# Kenya Power

*Our Ref: KP10/9A/PT/1.1/5/HRA/01/15-16*

**ADDENDUM NO. 1 TO THE TENDER NO.KP10/9A/PT/1.1/5/HRA/01/15-16 FOR RENOVATIONS AND REFURBISHMENT OF RUIRU GO-DOWN.**

**PROPOSED WINDOW GRILL AT RUIRU GO-DOWN**

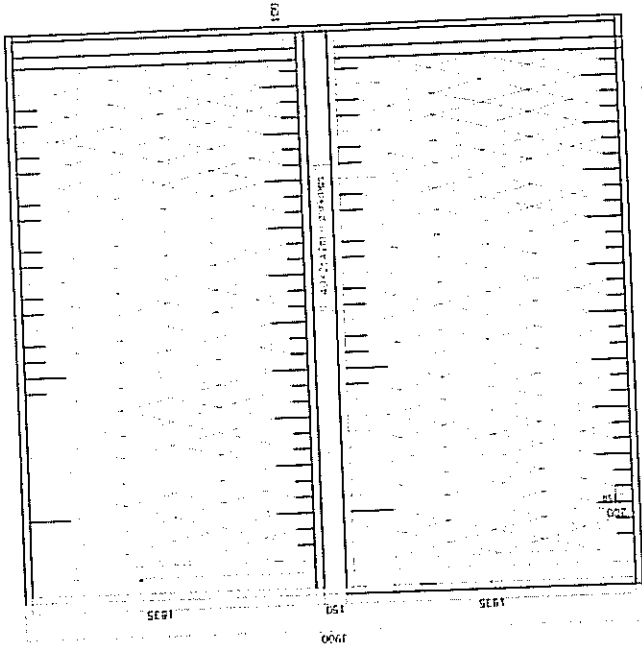
**Answer:** Remove all the window panes and replace with 4mm thick clear glass appropriately.
5. **Question:** Will Kenya power provide, the corporate window grills drawings and the stairs hand rails?

**Answer:** Yes we will provide that (See drawing attached).
6. **Question:** Is the mabati wall cladding and the roofing sheets gauge 16 or gauge 24 there is a disconnect between the drawing and the BQ. IT4 is not available in the market can IT5 be used instead?
